National Weigh Right Programme

ADDENDUM to the ROAD SAFETY AUDIT of DETAIL DESIGNS: SH1, MacKays Crossing

**A REPORT PREPARED FOR
NEW ZEALAND TRANSPORT AGENCY**

**Reference: 19359
August 2020**

Figure 1: Site location

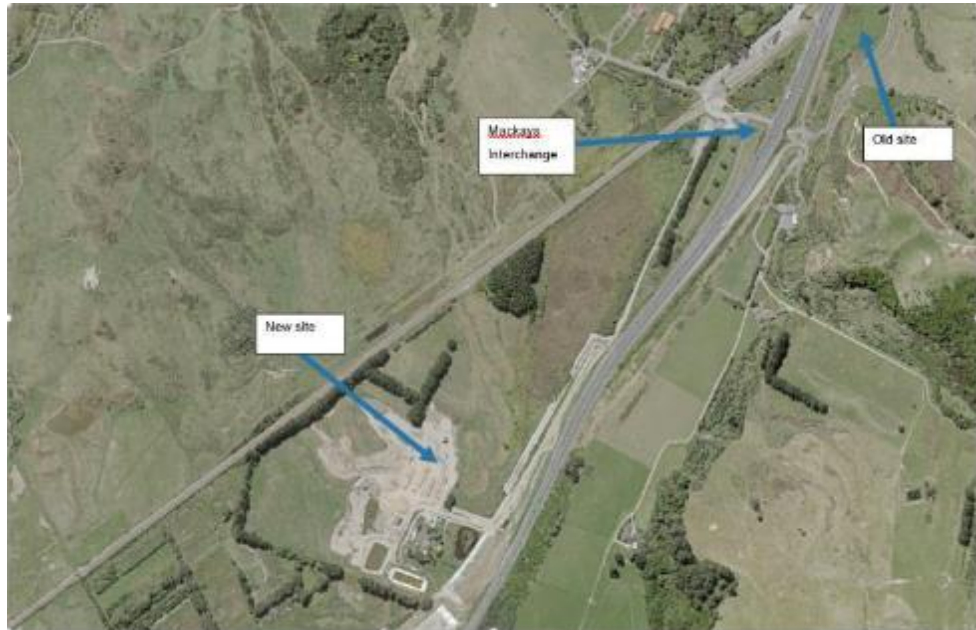
This road safety audit reviews the design for the site located near MacKays Crossing, Paekakariki. This site is a new location for one that was previously safety audited (see **Figure 1**) and the scope of the works comprises new CVSC, VSS and some road widening at the CVSC access to enable a right turn bay to be installed. Some of the works related to this facility fall within the Transmission Gully project that is currently under construction.

Figure 13: CVSC site, nr MacKays Crossing

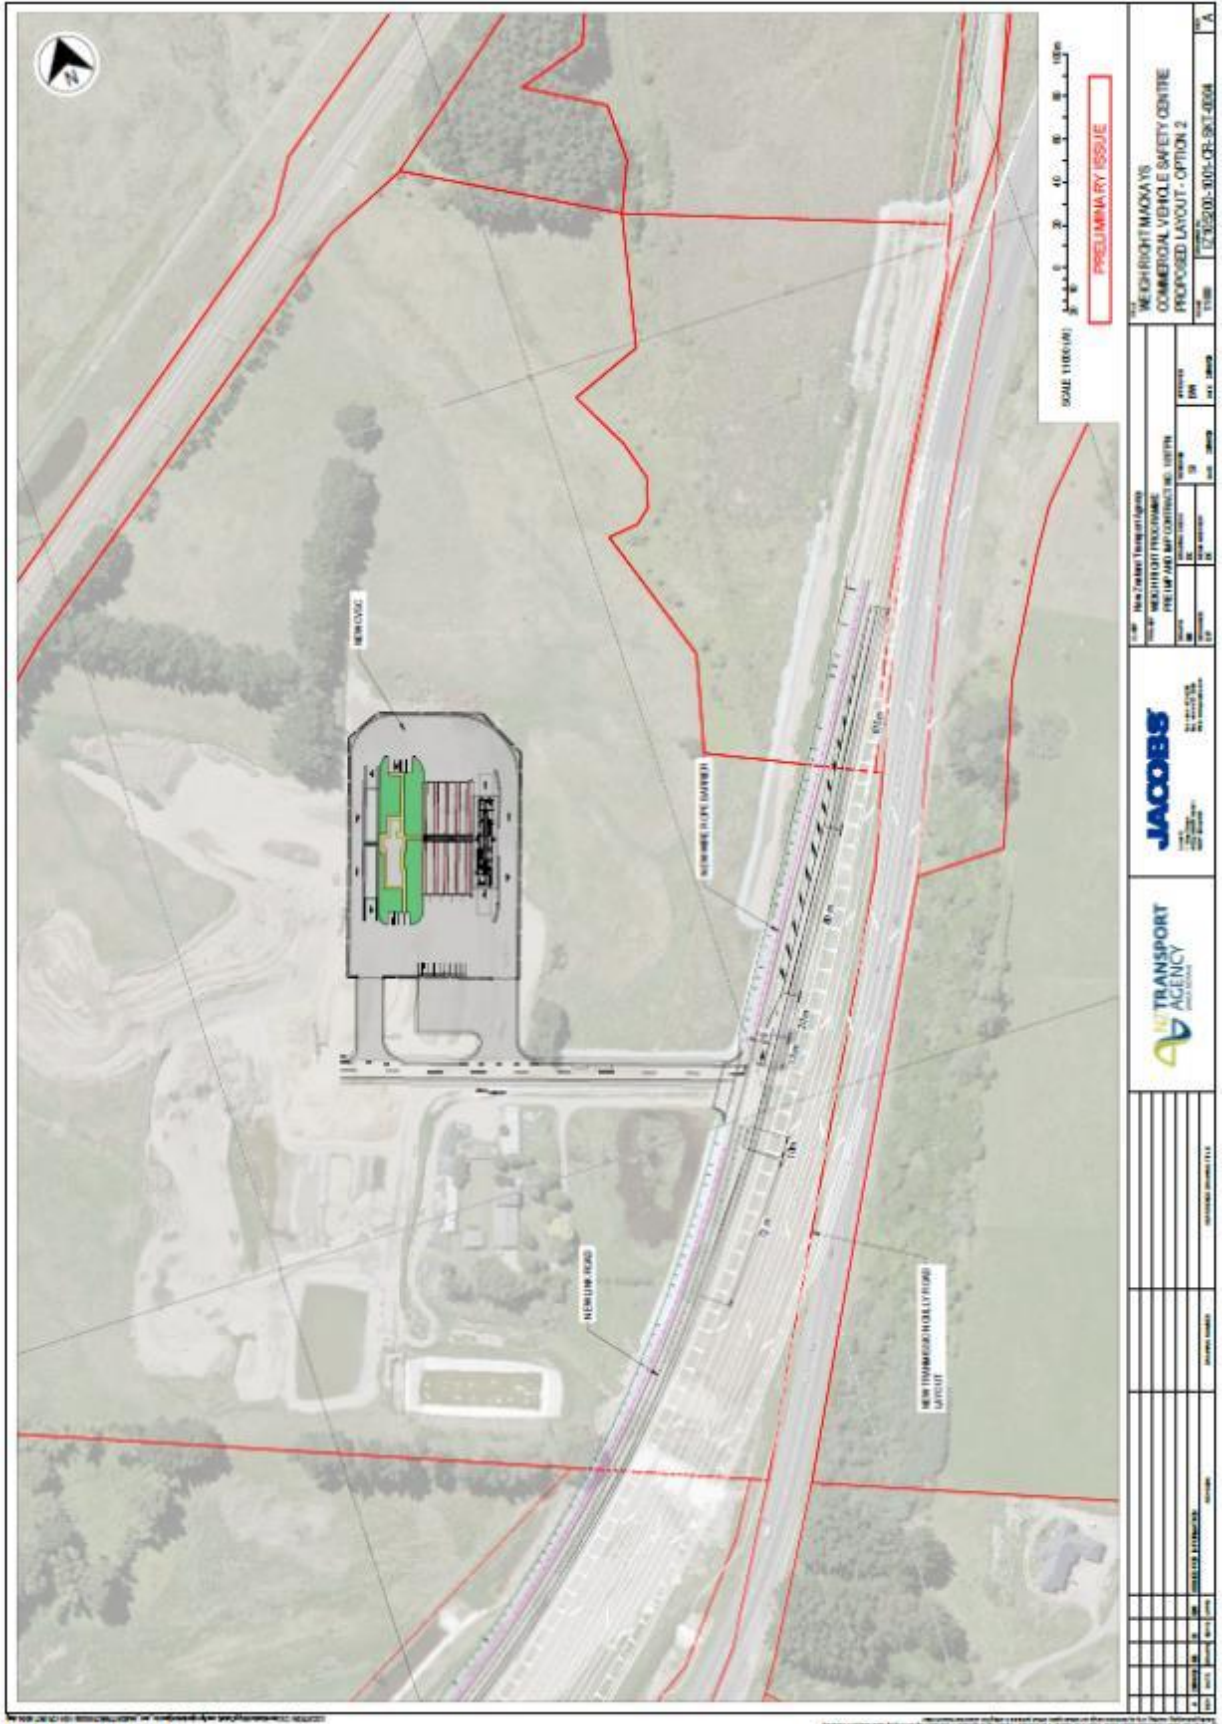
The SAT endorses the proposals to widen the new link road to provide a right turn bay at the CVSC access and to square up the CVSC access to 90° to the alignment of the new link road.

It was noted in the Traffic Assessment that the access has a sight line distance of 100m. It is assumed that this is due to the curvature in the road and the trees on the southern boundary of the site (see **Figures 8 and 9**), though there would appear to be more than 100m of clear visibility. Whilst the sight distance appears to be adequate for safe

operation, it would be prudent to check this when the trees on the boundary have full foliage and cut back any vegetation that restricts visibility to oncoming traffic.

Designer Response:	Noted. The possible removal of trees will be addressed in relation to any visual screening requirements given by the Council and Jacobs will provide advice on any visibility requirements.
Safety Engineer:	Agree with designers response. Ensure adequate sight distance is provided for the expected operating speed of traffic.
Client Decision:

Figure 14: CVSC site layout

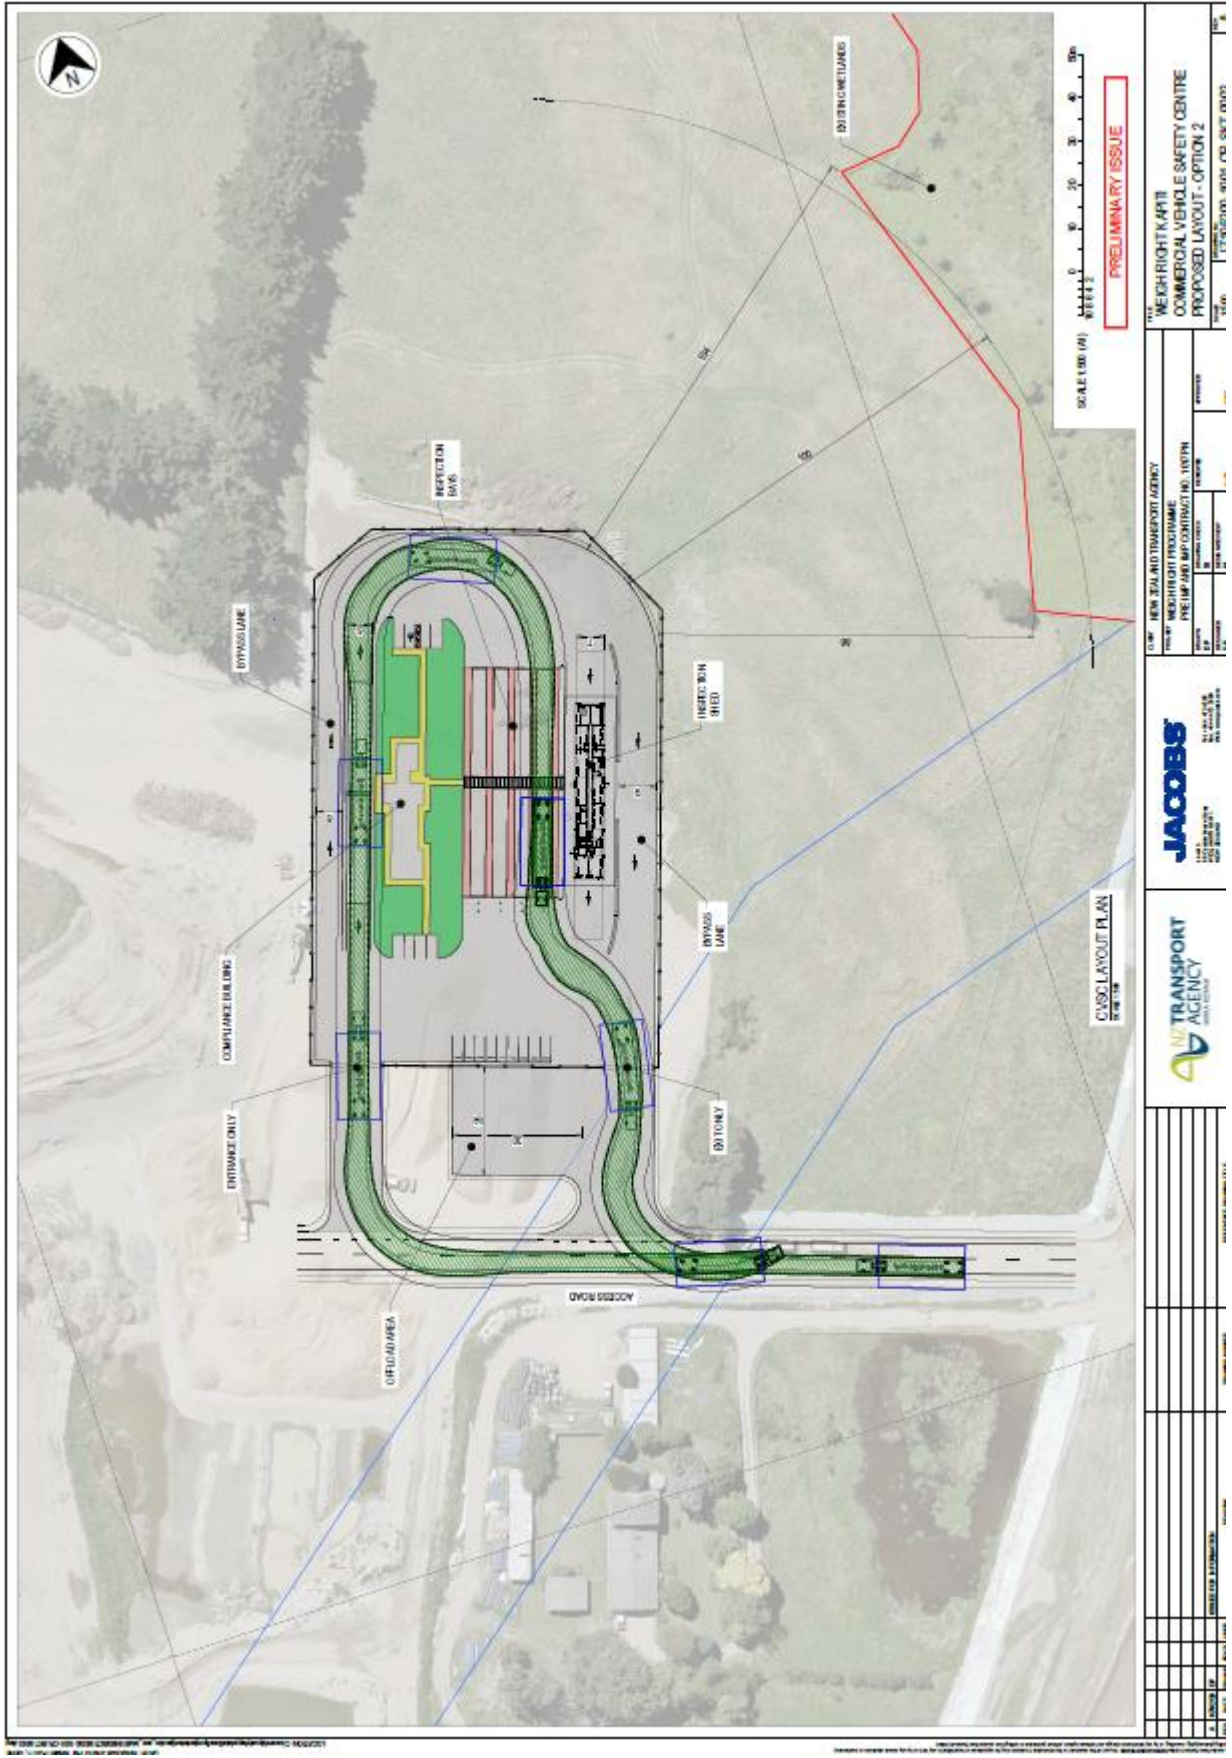
An acceleration lane is proposed to assist trucks turning left onto the new link road at the CVSC exit. Acceleration lanes are designed to allow slow vehicles to accelerate and merge into through traffic without interrupting the higher speed flow. The link road is forecast to carry approx. 220 vehicles per hour at peak times. Despite the road having a 50 km/h speed limit, speeds are likely to be noticeably higher as the road will have a 10m wide carriageway, safety barriers and no side friction.

The low traffic flow will mean significant gaps in traffic for trucks to safely exit the CVSC. However, when a truck is seen by a northbound driver to be exiting, there is the likelihood that some drivers will attempt to speed past the truck before it reaches the merge area. Given the low traffic flow, the SAT considers that it may be more appropriate not to have an acceleration lane for exiting trucks so that any northbound driver closing in on the truck is forced to slow down rather than potentially accelerate.

Reconsider the need for the proposed acceleration lane at the CVSC exit.

Designer Response:	There is no acceleration lane proposed here, just the extended right turn bay to allow trucks to stack safely when turning into the CVSC. SAT to provide clarification on this issue.
Safety Engineer:	Agree with designers response. Traffic volumes will be very low, if any, and no acceleration lane is required. Not sure an extended right turn lane is required, due to very few through traffic (where would the through traffic be going to or coming from – only those heading northbound and trying to access Paekakariki would be using this link road).
Client Decision:	
Action Taken:

Figure 16: WIM location Coast Road northbound

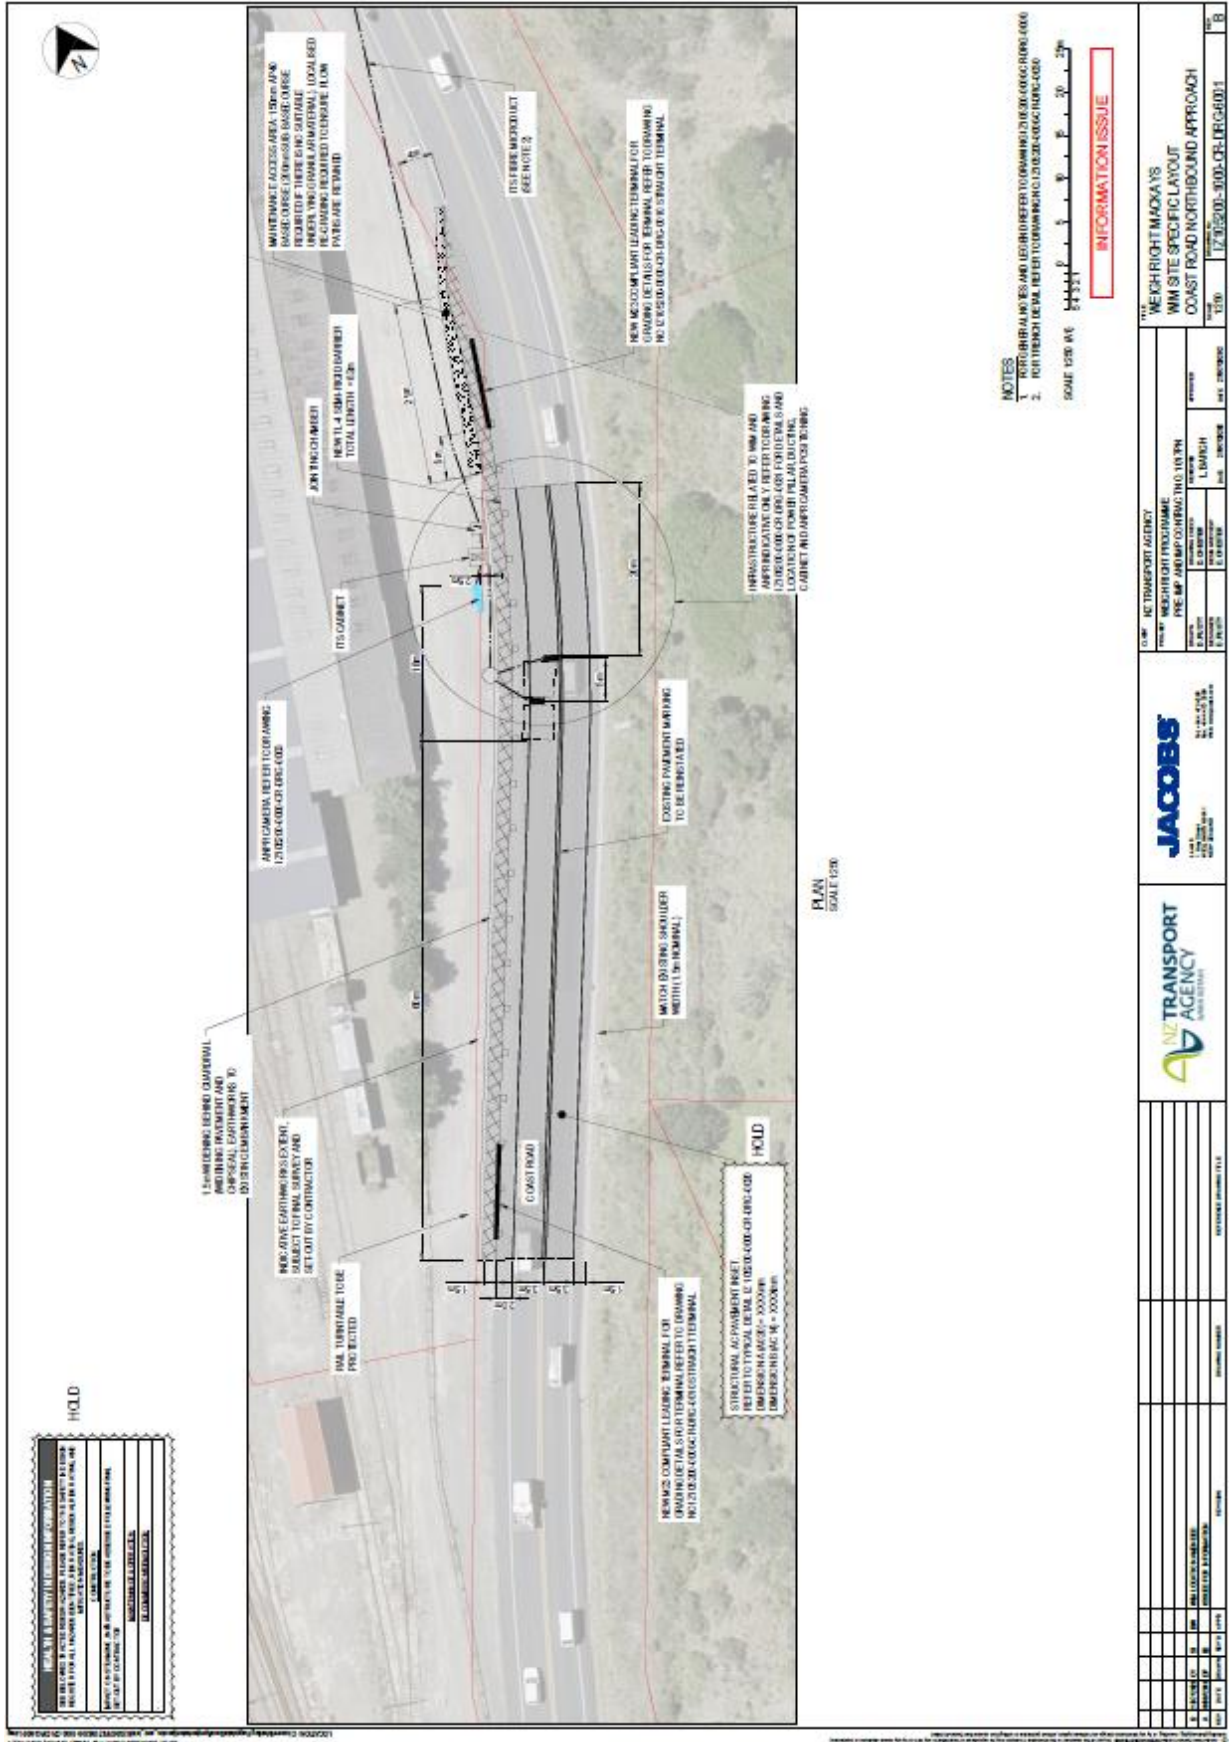
The WIM is to be located and safety barrier protected in an area where there is adequate room for maintenance vehicles to access the equipment (see **Figure 11**). This area is also used by drivers who stop to watch activity associated with the Steam Incorporated railway heritage society based alongside the highway. The unsealed area has a number of potholes and the safety barrier will direct drivers to enter at one location – it will be important that drivers can safely enter the area from the 80 km/h highway without encountering potholes.

Designer Response:	The surfacing behind the Coast Road WIM will be reviewed and addressed as part of the revised detailed design, to ensure safe access to the area.
Safety Engineer:	Agree with designers response. This area to be surfaced if at all possible. It is regularly used by all vehicles, and there are regular events at Steam Incorporated.
Client Decision:
